CITY OF STOUGHTON, 381 E. MAIN STREET, STOUGHTON, WIS CONSIN

RESOLUTION OF THE COMMON COUNCIL

Resolution by the Common Council of the City of Stoughton Conditionally Approving the Preliminary Plat of Kettle Park West

Exhibit B

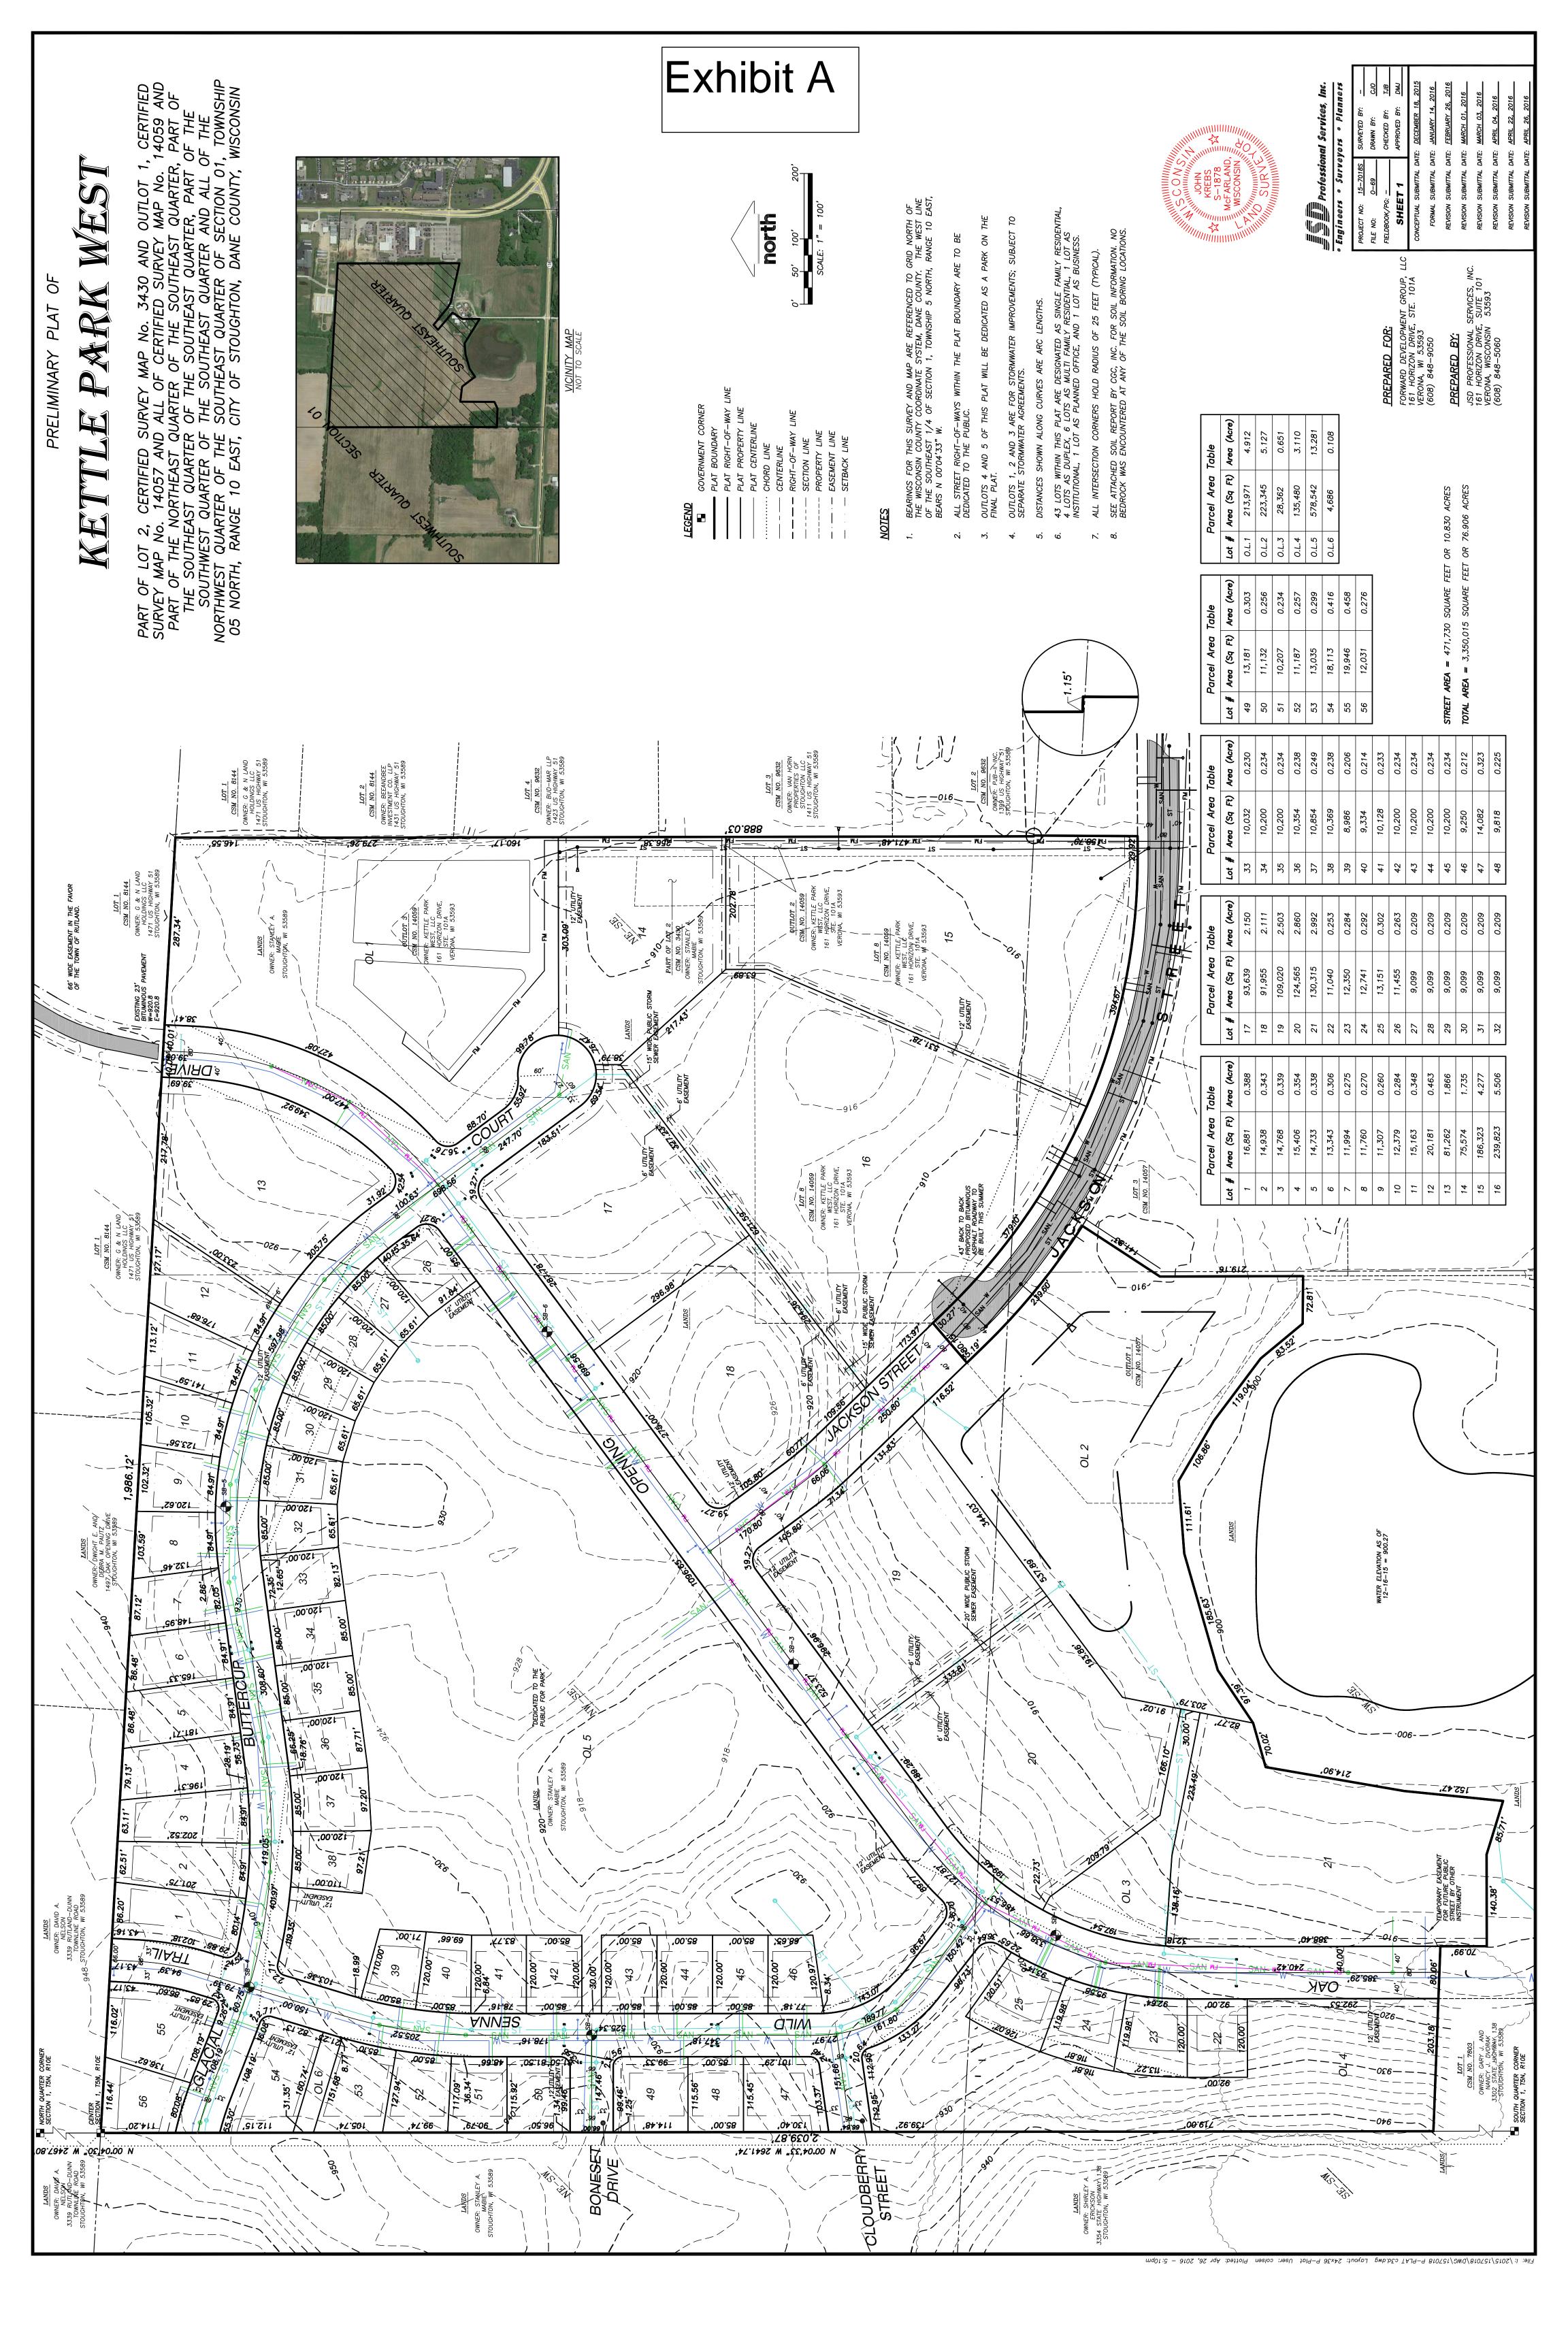
The Development Agreement will make reference to four subareas within the Plat ("Area A", "Area B", "Area C", and "Area D"), corresponding with the areas depicted on Exhibit B attached to this resolution. The Development Agreement shall anticipate that a separate final plat for Area A will be submitted for the City's approval, first, and that one or more final plats for Areas B, C and D will follow once all conditions for such areas have been satisfied.

- (a) <u>Area A</u>. No building permits for construction on Lot 16 of Area A will be available until the Developer has caused Jackson Street to be extended to the western boundary of Lot 16.

- (b) Areas B, C and D. Before the City will sign a final plat for Areas B, C and D: (i) the Developer must be obligated to install all of the streets, utilities, sidewalks, street lighting, and other public improvements required to serve those areas; (ii) a plan or agreement, acceptable to the City, must be in place for the completion of street improvements within the Town of Rutland, including bike/pedestrian accommodations and traffic signals at the Roby Road/Deer Point Drive and USH 51 intersection); and (iii) the connection of Oak Opening Drive to Highway 138 has been resolved to the City's satisfaction.

- 7. Outlot 5, which is located within Area C on the attached Exhibit B and Outlot 4, which is located within Area D, are intended to be dedicated to the public for park purposes on the final plats that will implement the preliminary plat. If the Developer wishes to record a final plat for land within Area A prior to the dedication of Outlots 4 and 5, the Developer will be required to provide the City a cash escrow, at the time of building permit issuance for any residential use, in an amount equal to the City's standard fee-in-lieu of parkland dedication, as surety for the Developer's obligation to dedicate Outlots 4 and 5. If a final plat dedicating Outlots 4 and 5 has not been recorded within three (3) years of the date the cash escrow was deposited with the City, the escrow shall be released to the City. The
